Economic Commission for Europe**Inland Transport Committee****World Forum for Harmonization of Vehicle Regulations****Working Party on Passive Safety****Seventy-fourth session**

UN Regulation No. 14 (Safety-belts)

**Proposal for the 10 series of amendments to UN Regulation
No. 16 (Safety-belts) *****Submitted by the expert from Japan**

Figure 1
Photo of the Buckle Strap Path of the UN Regulation No. 129 Test Bench

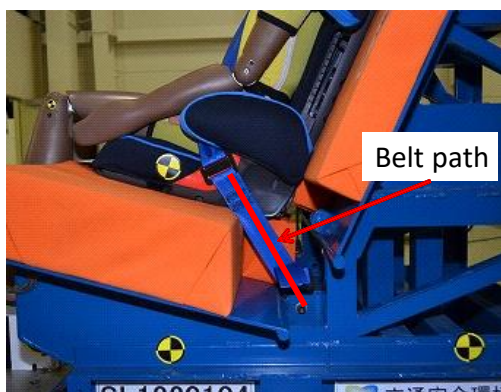
1. The strap's paths between the effective safety-belt anchorage and the buckle are normally straight like the test bench specified in UN Regulation No. 129 (Figure 1). However, the strap's paths between the effective belt-anchorage and the buckle of some vehicles in the market are not straight and are curved along the cushion (Figure 2).

Figure 2
Photo of the Buckle Strap Path When Not Straight

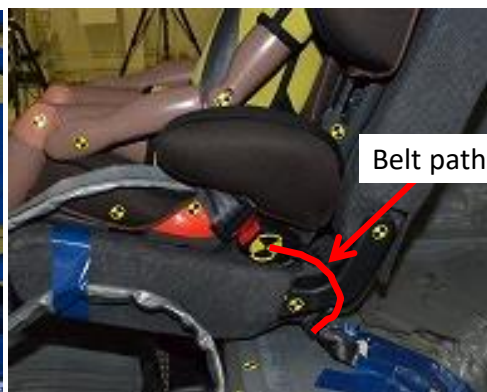
2. When the strap's paths between the effective belt anchorage and the buckle are not straight, the occupants may move significantly forward during a frontal impact accident. If an occupant is seated in the booster seat attached by ISOFIX, there are cases in which the seatbelt slips up to the neck and in which submarining occurs (referred to in GRSP-69-24). These phenomena would increase the risk of injuries to the neck and abdomen of a child occupant. In addition, the dummy chest injury increases. Figure 3 shows the relation between the amount of slack of the buckle strap and dummy 3 ms chest maximum acceleration for two types of CRS. When the slack of the buckle belt was over [50] mm, the chest maximum acceleration approached UN Regulation No. 129 criteria in one CRS. When the slack of the buckle belt was over [80] mm, the chest maximum acceleration exceeded the above-mentioned criteria.

- 8.2.3.1. **The difference between the actual strap length and the straight line distance between the EA and Bd point should be 50 mm or less.**
- The above requirements may be shown by the actual vehicle, parts, drawings, or 3D data at the manufacturer's discretion.**

Figure 3
Relation between the Amount of Slack of the Buckle Strap and Dummy 3ms Chest Maximum Acceleration

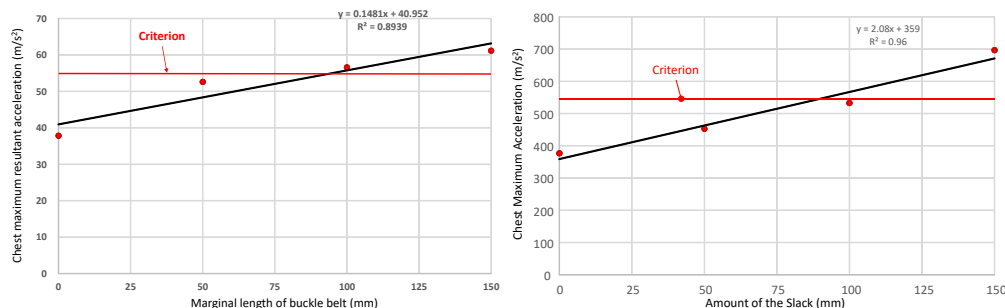
3. The slack of the buckle belt makes the passenger's excursion larger, negatively affecting the safety of the occupant (referred to in GRSP-70-32).
4. Therefore, we propose to limit the slack of the buckle-belt.
5. These amendments prevent the negative affects to the safety of the occupants.
